From: Gary L. Smith [<mailto:glg@wright-pierce.com>]
Sent: Wednesday, February 07, 2007 7:07 AM
To: Neil P. Cheseldine (npc@wright-pierce.com); Peter C. Atherton (PCA@wright-pierce.com); Peter J. Wilson (pjw@wright-pierce.com)
Subject: Wolf- Elevation Survey Error

From: Neil P. Cheseldine [npc@wright-pierce.com]
Sent: Tuesday, February 20, 2007 10:34 AM
To: 'David Ford'
Cc: 'Peter C. Atherton'; 'Peter J. Wilson'; 'Melissa Hamkins'; 'Gary L. Smith'; 'Richard N. Davee'
Subject: Wolfeboro - Phase 3 Hydrogeo report status

TO:	WP Wolfeboro Team	DATE:	June 16, 2009
FROM:	Jesse Schwalbaum	PROJECT NO.:	10922
SUBJECT:	Additional Wolfeboro Modeling

TO:	Dave Ford	DATE:	11 June 2009
FROM:	Melissa Hamkins	PROJECT NO.:	10922H
SUBJECT:	Action Plan for addressing RIB site Start up and Operational Issues

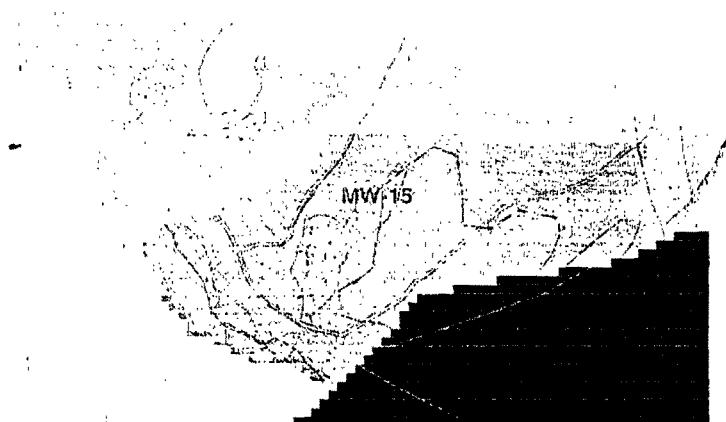
This brings us to the second possible conclusion (back in paragraph 3). The primary parameters within the model are hydraulic conductivity (K) and recharge. I have not yet been able to find a combination of K and recharge that provides a good match for the observed starting water levels, the observed mound and the observed seeps. And this is by no means a hit-or-miss process, as in the old days. I have a calibration program that tweaks all of the model parameters systematically and compares the results to observed conditions over and over again for hundreds of model runs. This is why I've actually been able to get other work done this week. But the fact that this program has not been able to come up with a close match suggests that there is something structural in our conceptual model of the aquifer that does not match reality. By structural, I mean that either: 1) the assumed bedrock elevations are off in significant areas of the model, 2) there is channeling of water on or in the bedrock, 3) there is channeling of water through coarse gravel deposits or 4) there is till and bedrock in areas that the model assumes is sand and gravel. The calibration program that I have been using suggests that the latter is one likely candidate because it is insisting that the K values in some areas (in the southeast region of the model) should be below 1 ft/day. This is a value more representative of till than sand.

In other words, our conception of how groundwater moves through this aquifer is incomplete and no amount of modeling is going to be able to fill the gap in a satisfactory way. I think it is safe to assume that there are reasons that these seeps have occurred. But the model is not providing us with all of those reasons because there is something about that aquifer that we do not know. We do not even know if these seeps are an unusual occurrence. In many areas, groundwater seeps on steep slopes are a normal occurrence in wet springs.
